| Model: Martini-P2 | Date: 10-Aug-06 | No.: RG148001b |

| Subject: Firmware Release History (Engine)        |  | Prepared by: S. Watanabe                           |  |

| Subject: Connecting the LCIT RT43 with the MT-P2  |   | Prepared by: S. Watanabe                  |  |

| Subject: Thread-cutting error on the LCT Connection Unit |  | Prepared by: S. Watanabe  |   |

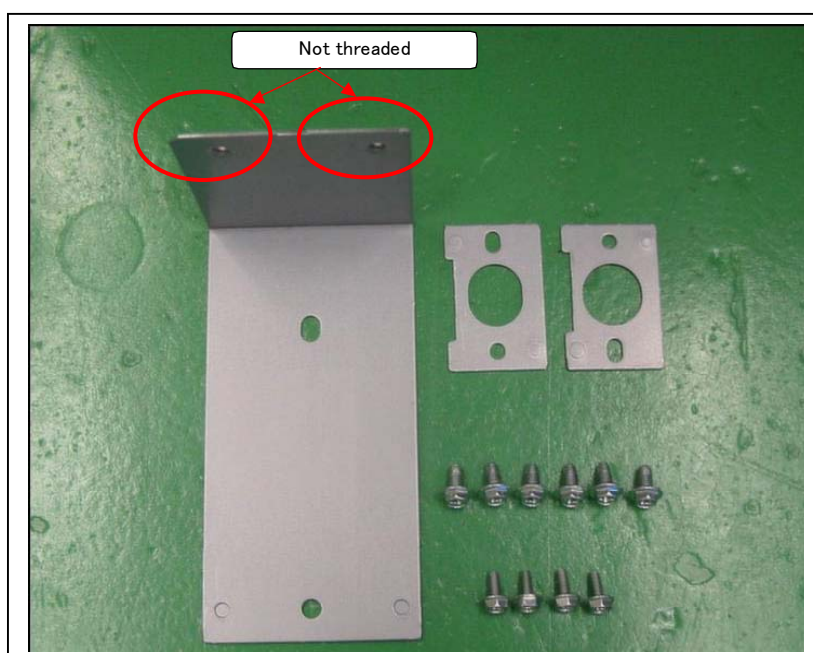
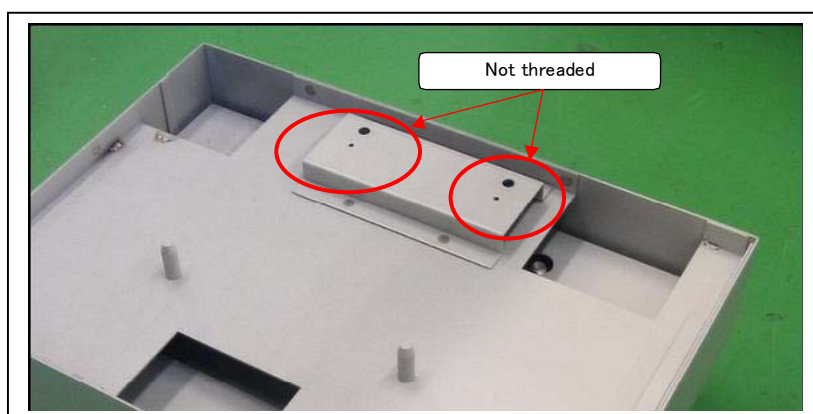
## SYMPTOM

The LCT Connection Unit Type A (G845) cannot be connected to the LCT RT43 (B473).

**Note:** This only occurs with units from July and August production.

## CAUSE

The holes shown in the photograph below were not threaded at the factory.

Use tapping screws for the holes that are not threaded (P/N 04514008N or similar M4 tapping screw).

The holes are threaded from lot number 200609.

Lot Number

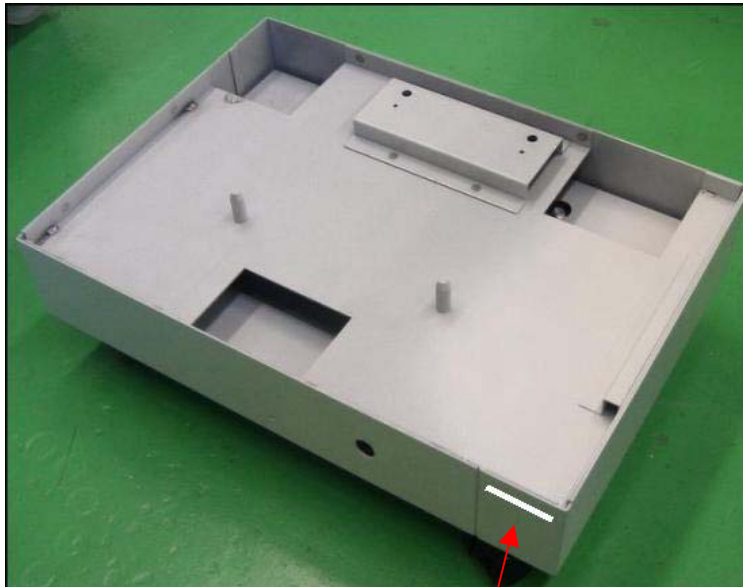
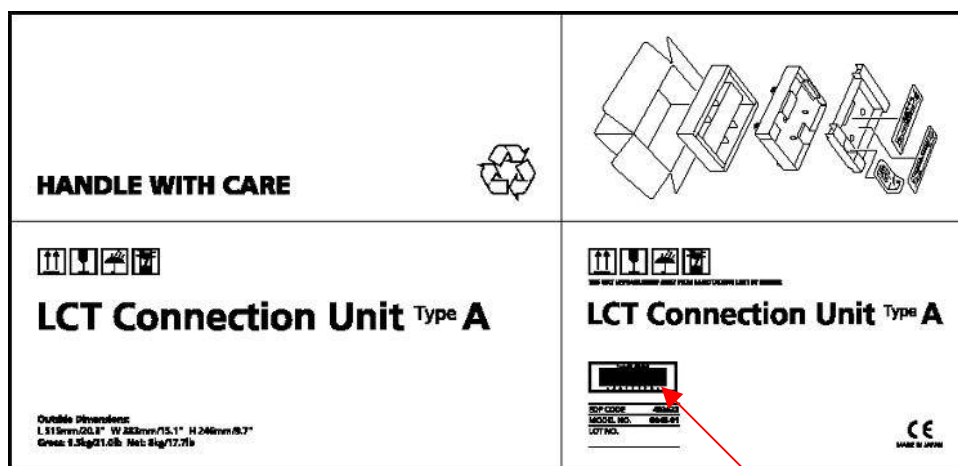
**Note:** You can check this lot number in the location shown in the photo.

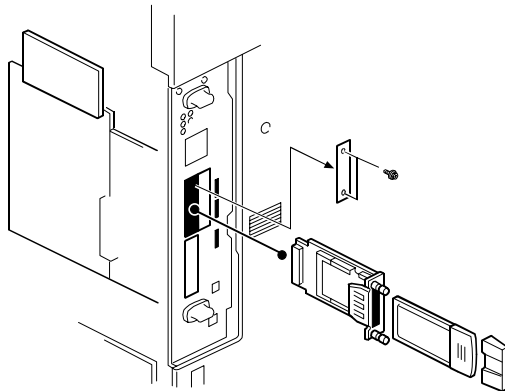
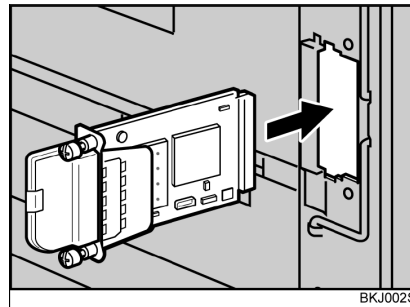
Previous types:  
PCB, LAN card, and cover are  
separate

New Type (IEEE802.11b  
Interface Unit Type N):  
Pre-assembled
